# MAINTENANCE BULLETIN

NO. 159  
AUGUST 1998

**SUBJECT: MAINTENANCE ADVISORY MESSAGE (MAM), TACOM-WRN  
CONTROL NO. MAM-98-006, FOR ALL M998 AND M998A1 SERIES HIGH  
MOBILITY MULTIPURPOSE WHEELED VEHICLE (HMMWV) EQUIPPED WITH  
100AMP ALTERNATOR**

**SUBJECT:** Rerouting Alternator Positive Cable

Figure 1

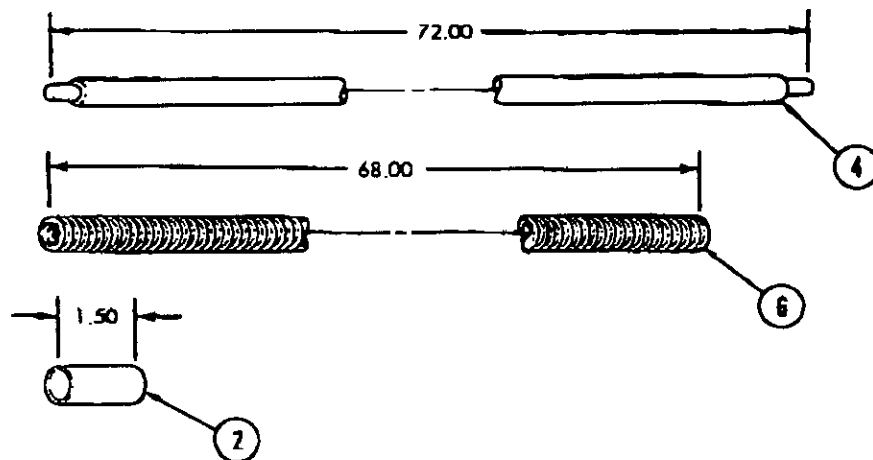
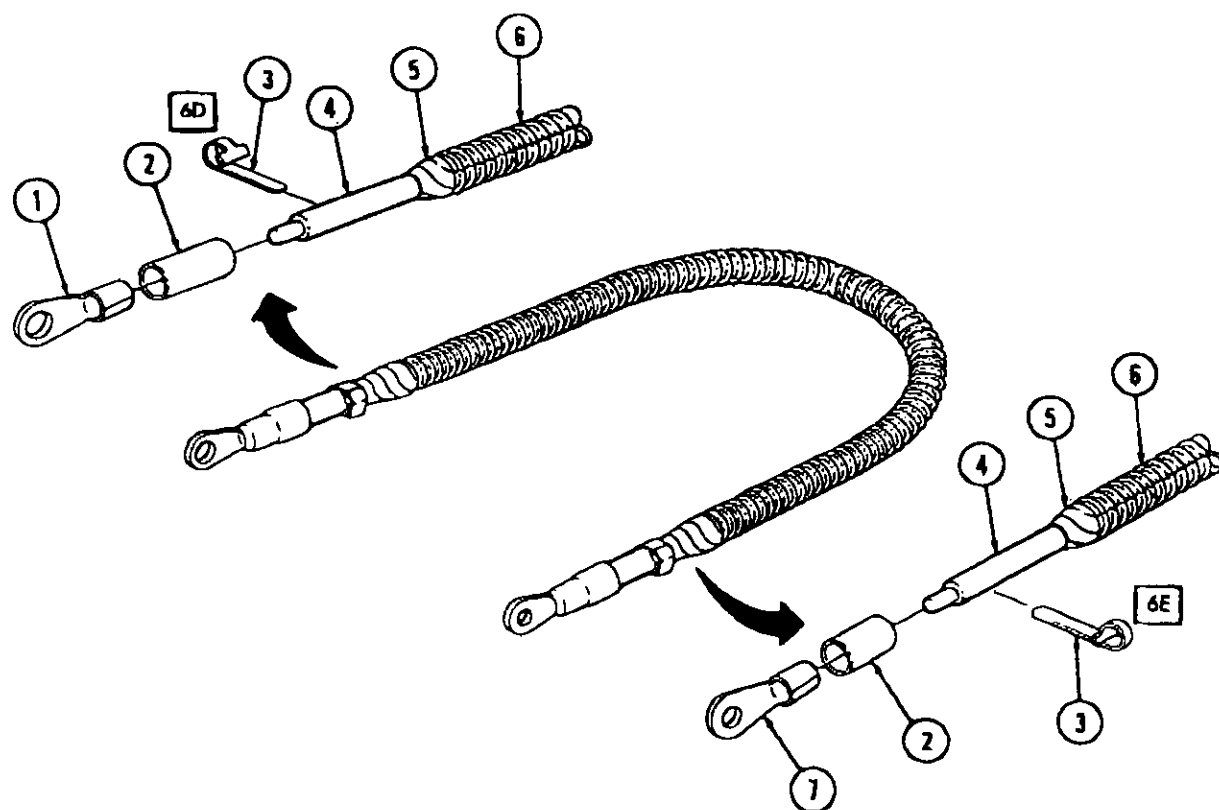
1. Using NSN 6145-00-538-8222 electrical wire (4), cut a 72.00-in. section as shown in figure 1.
2. Using NSN 5970-01-344-4689 convoluted conduit (6), cut a 68.00-in. section as shown in figure 1.
3. Using NSN 5970-00-812-2967 insulation sleeving (2), cut two 1.50-in. sections as shown in figure 1.
4. Place convoluted conduit (6) over electrical wire (4) as shown in figure 1.
5. Position convoluted conduit (6) 3.00-in. from end of electrical wire (4) and secure both ends of convoluted conduit (6) to electrical wire (4) with NSN 5970-00-644-3167 electrical tape (5) as shown in figure 1.

6. Place insulation sleeve (2) over end of electrical wire (4) and connect NSN 5940-00-114-1315 terminal lug (1) to electrical wire (4) as shown in figure 1.

7. Position insulation sleeve (2) over electrical wire (4) and terminal lug (1) and secure by heat-shrinking insulation sleeve (2) as shown in figure 1.

8. Stamp identification number 6D on NSN 9905-00-893-3570 marker band (3) as shown in figure 1.
9. Install marker band (3) on electrical wire (4) as shown in figure 1.

10. Place insulation sleeve (2) over opposite end of electrical wire (4) and connect NSN 5940-00-115-2674 terminal lug (7) to electrical wire (4) as shown in figure 1.

11. Position insulation sleeve (2) over electrical wire (4) and terminal lug (7) and secure by heat-shrinking insulation sleeve (2) as shown in figure 1.

12. Stamp identification number 6E on NSN 9905-00-893-3570 marker band (3) as shown in figure 1.
13. Install marker band (3) on electrical wire (4) as shown in figure 1.

*Figure 2*

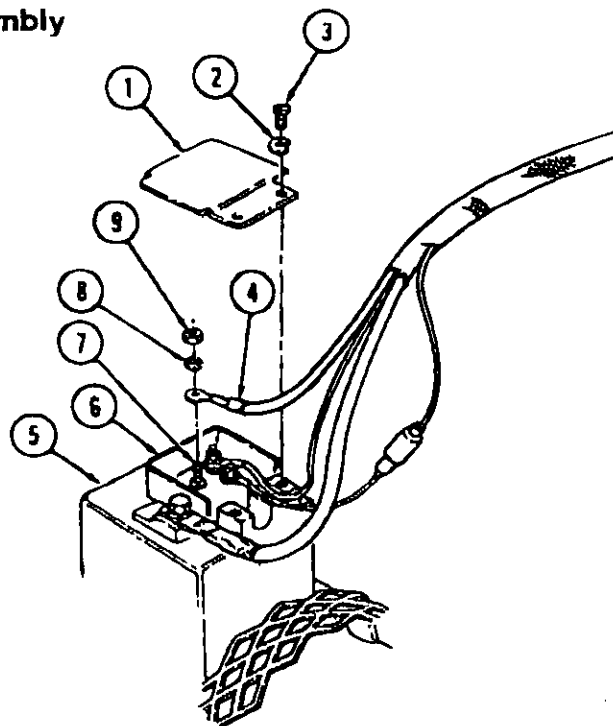
1. Remove two screws (3), lockwashers (2), and cover (1) from regulator (5) as shown in figure 2. Discard lockwashers (2).
2. Remove sealant from regulator cavity (6) as shown in figure 2.
3. Remove nut (9), lockwasher (8), and lead 5A (4) from regulator terminal (7) as shown in figure 2. Discard lockwasher (8).
4. Remove terminal lug (3) from lead 5A (1) as shown in figure 6.

*Figure 3*

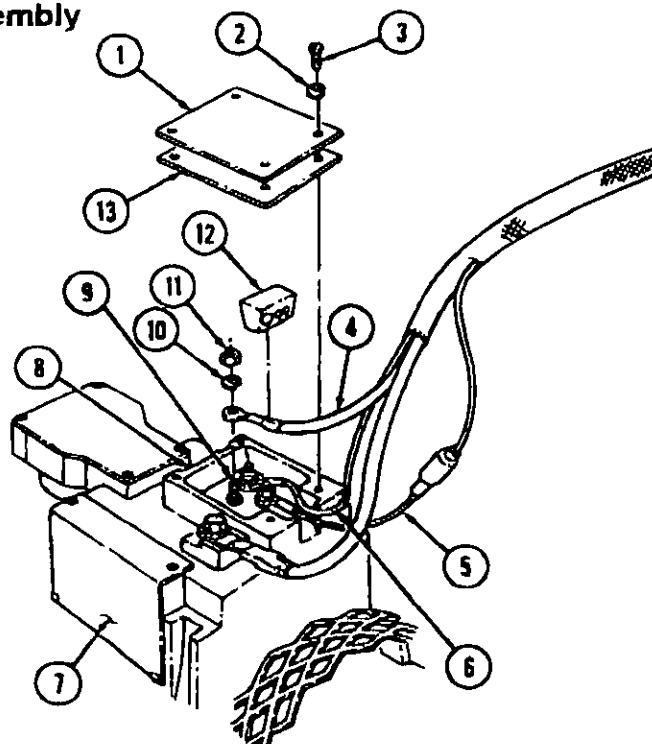
1. Remove four screws (3), lockwashers (2), and cover (1), and gasket (13) from regulator (7) as shown in figure 3. Discard lockwashers (2).
2. Remove sealing wedge (12) from regulator cavity (8) and wire leads (4), (5), and (6) as shown in figure 3.

3. Remove nut (11), lockwasher (10), and lead 5A (4) from regulator terminal (9) as shown in figure 3. Discard lockwasher (10).
4. Remove terminal lug end (3) from lead 5A (1) as shown in figure 6.

*Figure 4*

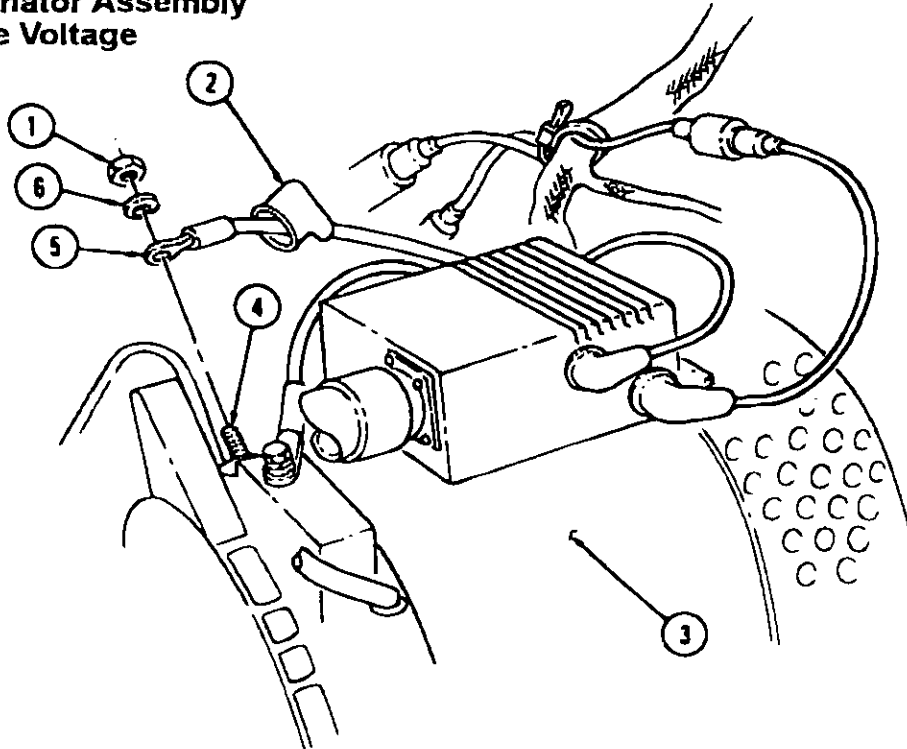
1. Slide boot (2) back, remove nut (1), washer (6), and lead 5A (5) from positive terminal (4) on alternator (3) as shown in figure 4.
2. Remove boot (2) from lead 5A (5) as shown in figure 4.

*Figure 5*

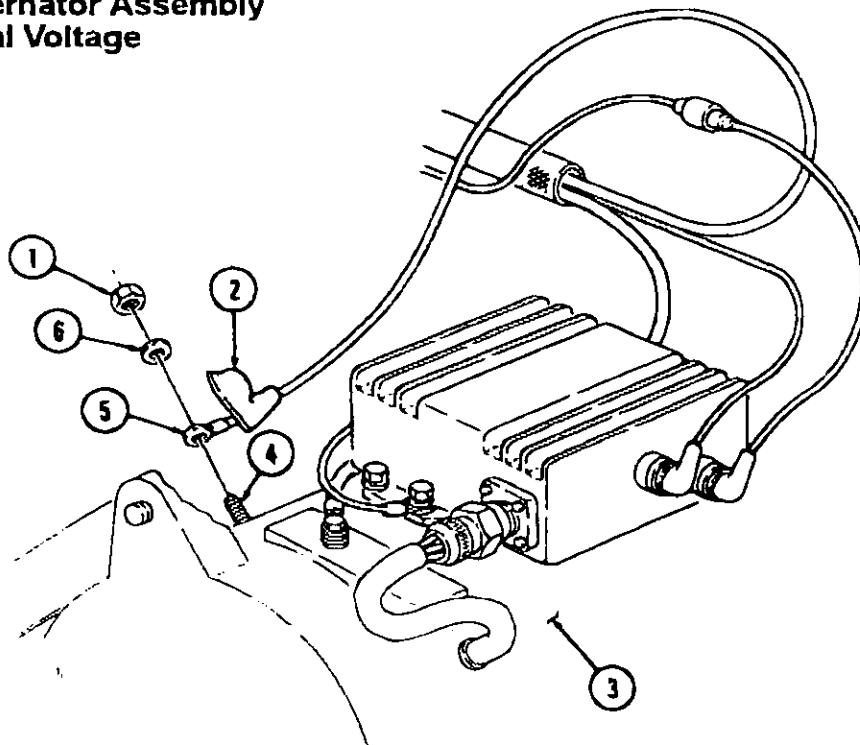
1. Slide boot (2) back, remove nut (1), washer (6) and lead 5A (5) from positive terminal (4) on alternator (3) as shown in figure 5.
2. Remove boot (2) from lead 5A (5) as shown in figure 5.

Figure 6

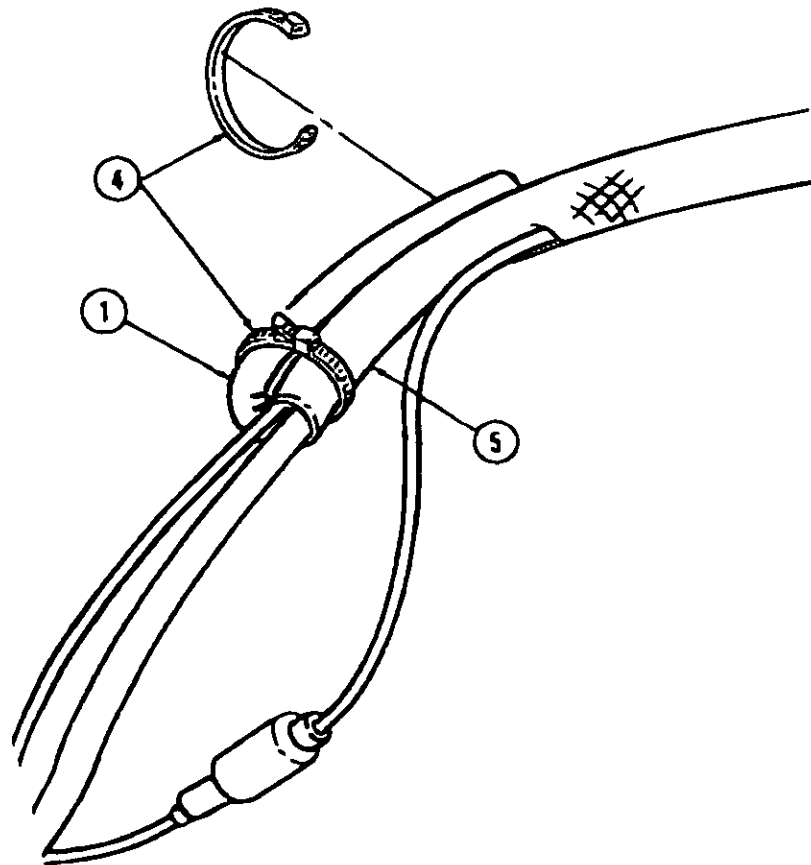
5. Using NSN 5970-00-812-2967 insulation sleeving (2), cut 3.00-in. section as shown in figure 6.
6. Position insulation sleeve (2) over lead 5A (1) to a point of 0.75-in. from end of lead 5A (1) as shown in figure 6.

7. Apply NSN 8030-01-328-0574 adhesive sealant to 0.75-in. open end of insulation sleeving (2) and secure insulation sleeving (2) to lead 5A (1) by heat-shrinking insulation sleeving (2) as shown in figure 6.

8. Bend lead 5A (1) over toward harness (5) and secure with two NSN 5975-01-034-5871 tiedown straps (4) as shown in figure 6.
9. Install positive cable lead 6E (6) on regulator terminal (11) with NSN 5310-00-582-5965 lockwasher (12) and nut (13) as shown in figure 8. Tighten nut (13) to 50 lb-in. (5.6 N-m).

3. Remove terminal lug (3) from lead 5A (1) as shown in figure 6.
4. Using NSN 5970-00-812-2967 insulation sleeving (2), cut a 3.00-in. section as shown in figure 6.

5. Position insulation sleeve (2) over lead 5A (1) to a point of 0.75-in. from end of lead 5A (1) as shown in figure 6.
6. Apply NSN 8030-01-328-0574 adhesive sealant to 0.75-in. open end of insulation sleeving (2) and secure insulation sleeving (2) to lead 5A (1) by heat-shrinking insulation sleeving (2) as shown in figure 6.

*Figure 7*

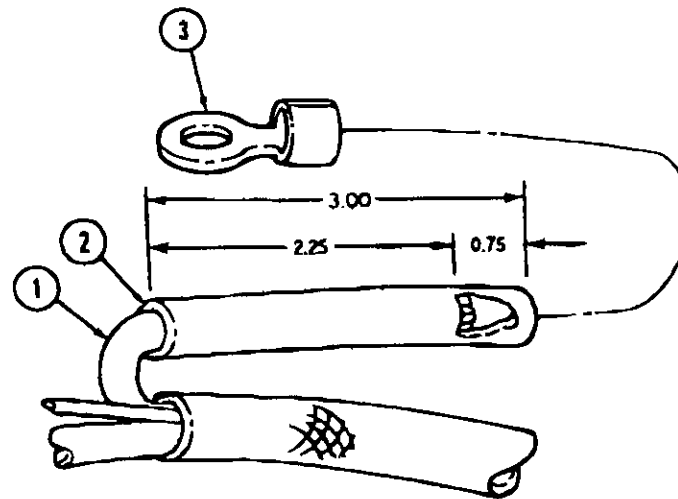
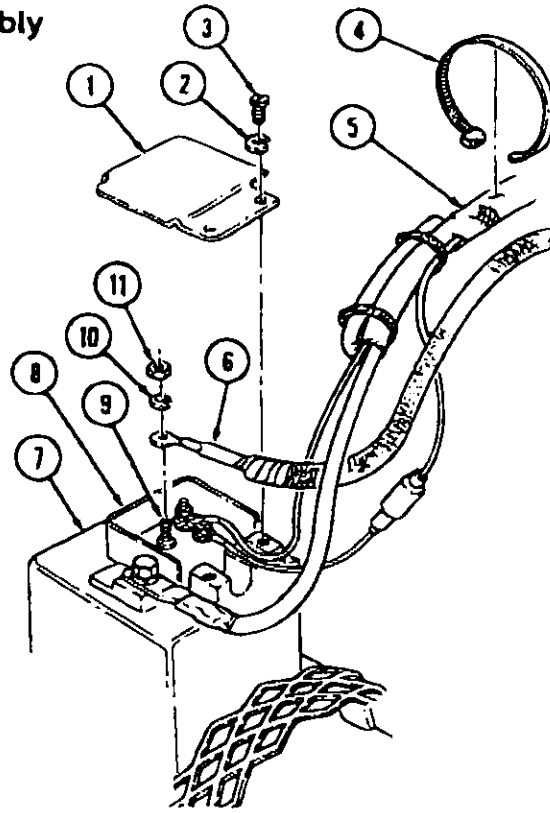
5. Using NSN 5970-00-812-2967 insulation sleeving (2), cut 3.00-in. section as shown in figure 6.
6. Position insulation sleeve (2) over lead 5A (1) to a point of 0.75-in. from end of lead 5A (1) as shown in figure 6.
7. Apply NSN 8030-01-328-0574 adhesive sealant to 0.75-in. open end of insulation sleeving (2) and secure insulation sleeving (2) to lead 5A (1) by heat-shrinking insulation sleeving (2) as shown in figure 6.
8. Bend lead 5A (1) over toward harness (5) and secure with two NSN 5975-01-034-5871 tiedown straps (4) as shown in figure 6.
9. Install positive cable lead 6E (6) on regulator terminal (9) with NSN 5310-00-582-5965 lockwasher (10) and nut (11) as shown in figure 7. Tighten nut (11) to 50 lb-in. (5.6 N-m).

10. Apply NSN 8030-01-328-0574 adhesive sealant to regulator cavity (8) and secure cover (1) to regulator (7) with two NSN 5310-01-162-9661 lockwashers (2) and screws (3) as shown in figure 7.
11. Secure positive cable (6) to harness (5) with NSN 5975-01-034-5871 tiedown strap (4) as shown in figure 7.
12. Proceed to Section V, Positive Cable Installation.

*Figure 8*

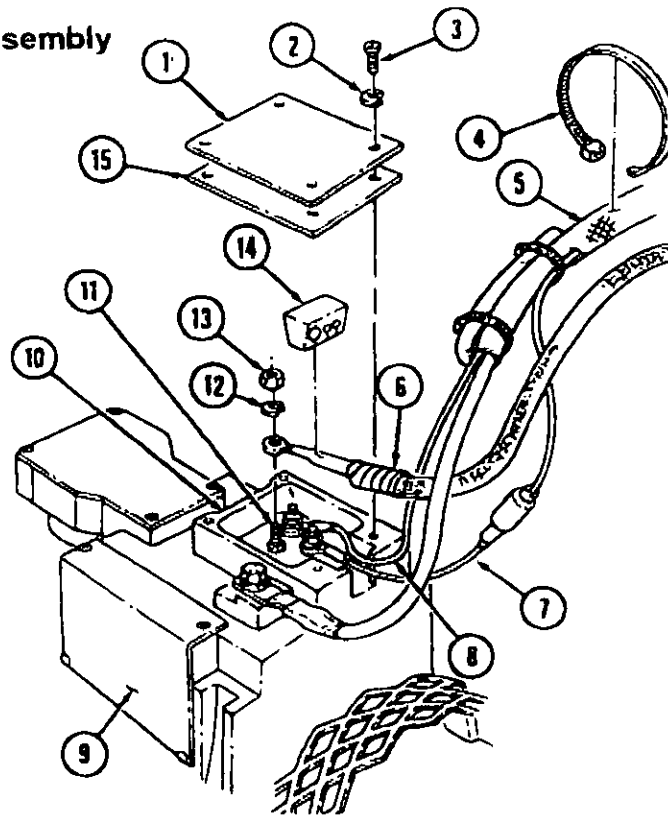
10. Install sealing wedge (14) on wire leads (6), (7), and (8) and place sealing wedge (14) in regulator cavity (10) as shown in figure 8.
11. Install gasket (15), cover (1), on regulator (9) with four NSN 5310-01-162-9661 lockwashers (2), and screws (3) as shown in figure 8.

12. Secure positive cable 6E (6) to harness (5) with NSN 5975-01-034-5871 tiedown strap (4) as shown in figure 8.
13. Proceed to Section V, Positive Cable Installation.

*Figure 9*

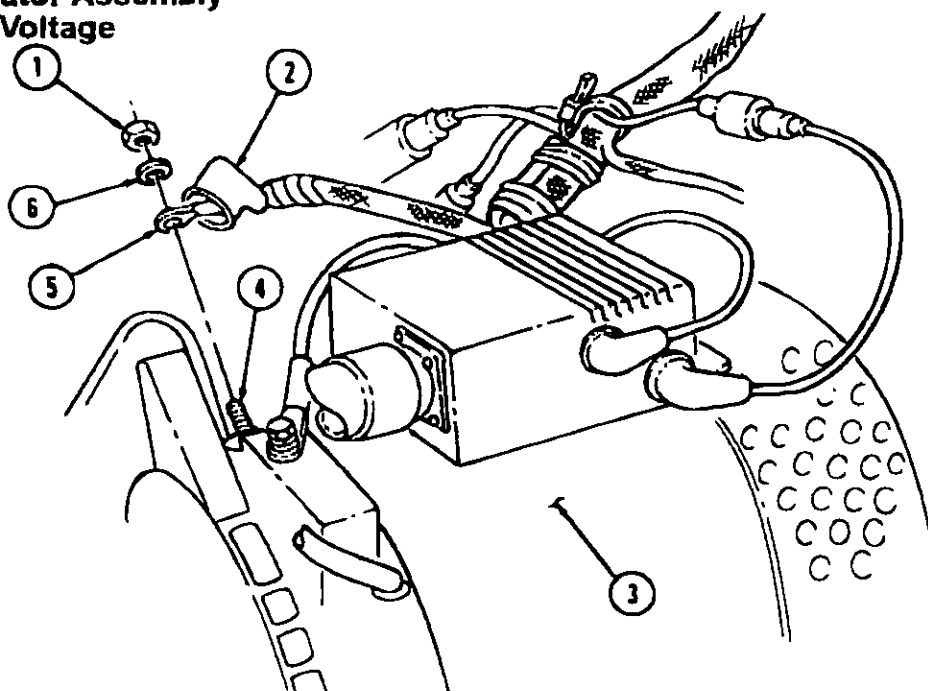
7. Bend lead 5A (1) over toward harness (5) and secure with two NSN 5975-01-034-5871 tiedown straps (4) as shown in figure 6.
8. Install P/N 214E2V02 boot (2) on positive cable lead 6E (5) as shown in figure 9.

9. Install positive cable lead 6E (5) on positive terminal (4) of alternator (3) with washer (6) and nut (1) as shown in figure 9. Tighten nut (1) to 65 lb-in (7 N·m).

10. Apply NSN 9150-01-015-1542 grease to inside of boot (2) and slide boot (2) over nut (1) and positive terminal (4) as shown in figure 9.
11. Proceed to Section V, Positive Cable Installation.

*Figure 10*

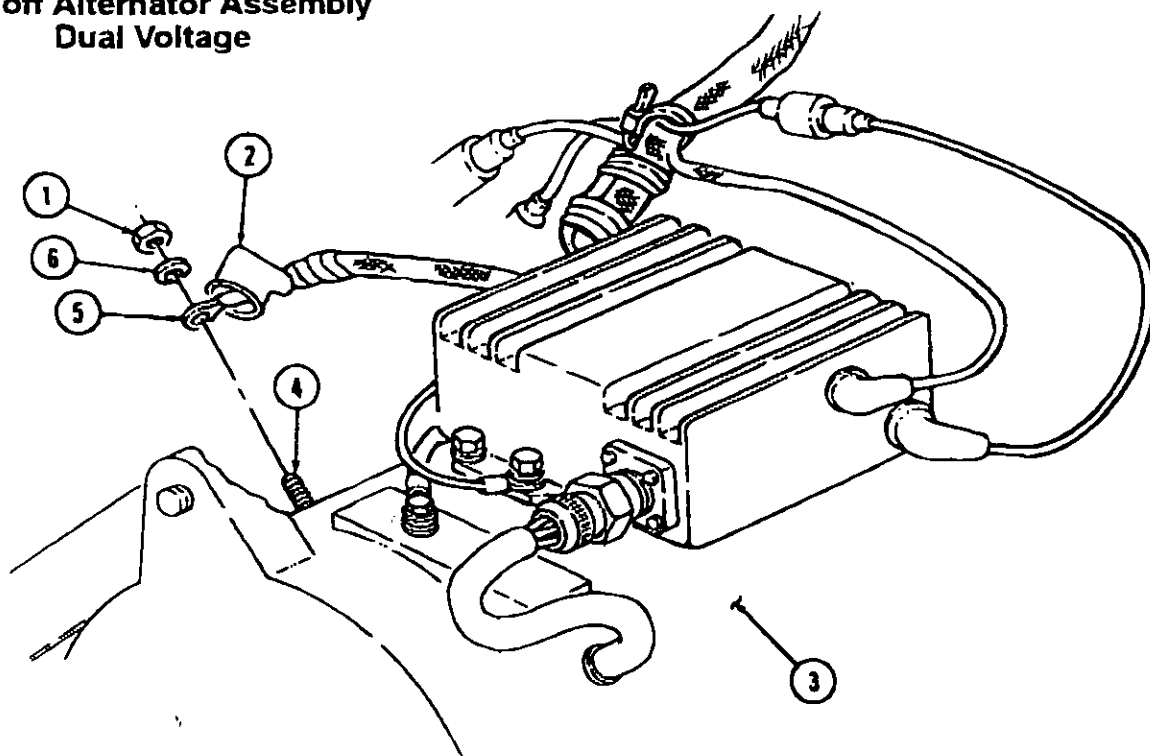
7. Bend lead 5A (1) over toward harness (5) and secure with two NSN 5975-01-034-5871 tiedown straps (4) as shown in figure 6.
8. Install P/N 214E2V02 boot (2) on positive cable lead 6E (5) as shown in figure 10.

9. Install positive cable lead 6E (5) on positive terminal (4) of alternator (3) with washer (6) and nut (1) as shown in figure 10. Tighten nut (1) to 65 lb-in (7 N·m).

10. Apply NSN 9150-01-015-1542 grease to inside of boot (2) and slide boot (2) over nut (1) and positive terminal (4) as shown in figure 10.
11. Proceed to Section V, Positive Cable Installation.

*Figure 11*

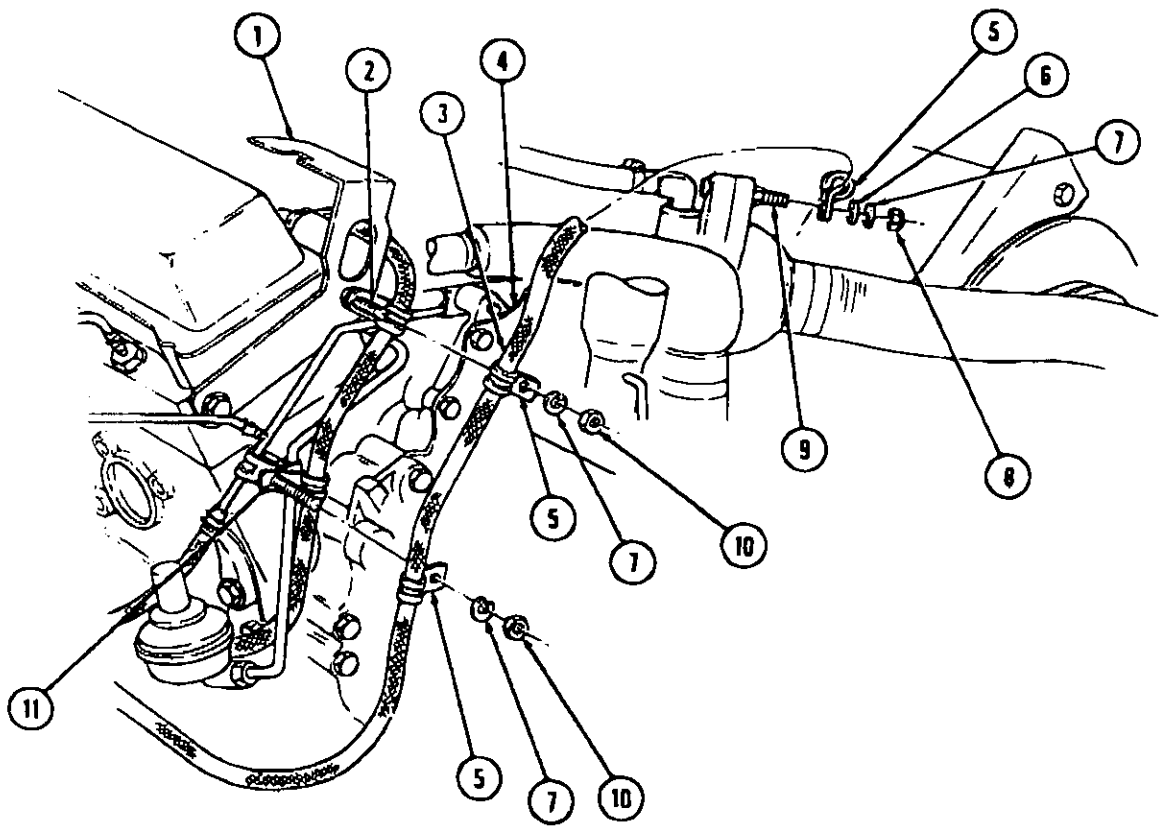
1. Route positive cable (3) over top of engine (4) as shown in figure 11.
2. Install NSN 5340-00-053-8994 clamp (5) on positive cable (3) and secure to crossover tube stud (9) with NSN 5310-01-210-1587 washer (6), NSN 5310-01-206-7306 lockwasher (7) and NSN 5310-01-315-1535 nut (8) as shown in figure 11.

3. Position positive cable (3) along right-side front of engine (4) as shown in figure 11.
4. Remove nut (10) and lockwasher (7) from stud (2) on engine lift bracket (1) as shown in figure 11. Discard lockwasher (7).

5. Remove nut (10) and lockwasher (7) from stud (11) on engine (4) as shown in figure 11. Discard lockwasher (7).
6. Install NSN 5340-00-053-8994 clamp (5) on positive cable (3) and secure to stud (11) on engine (4) with NSN 5310-00-206-7306 lockwasher (7) and nut (10) as shown in figure 11.

7. Install NSN 5340-00-053-8994 clamp (5) on positive cable (3) and secure to stud (2) on engine lift bracket (1) with NSN 5310-01-206-7306 lockwasher (7) and nut (10) as shown in figure 11.
